SUBJECT: DuPage Airport  
West Chicago, Illinois  
DuPage County  
Illinois Project Number: DPA-4300  
SBG Project Number: 3-17-SBGP-XX  
Contract No. DU081  
Item No. 05A, 6-10-2016 Letting  
Addendum A

## NOTICE TO PROSPECTIVE BIDDERS

05A  
6-10-2016 LETTING

## CONSTRUCT WEST END PERIMETER ROADWAY

project	88849	contract	DPA-4300
drawing	<b>CU-204</b>	rev.	
sheet	of	sheets	
file

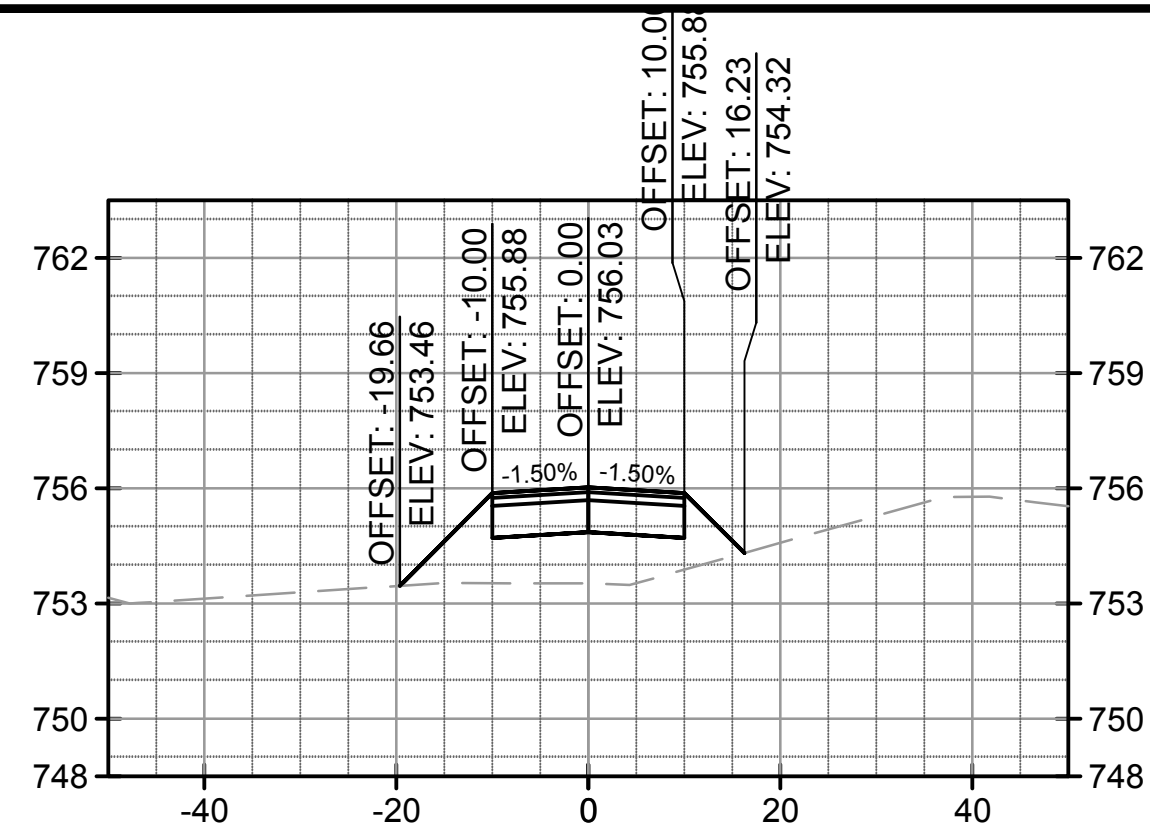
16. CU-202 and CU-204
  - Revision of storm sewer details
17. X-101, X-102, X-103, X-104, and X-105
  - Addition of cut and fill areas and volumes to plan sheets
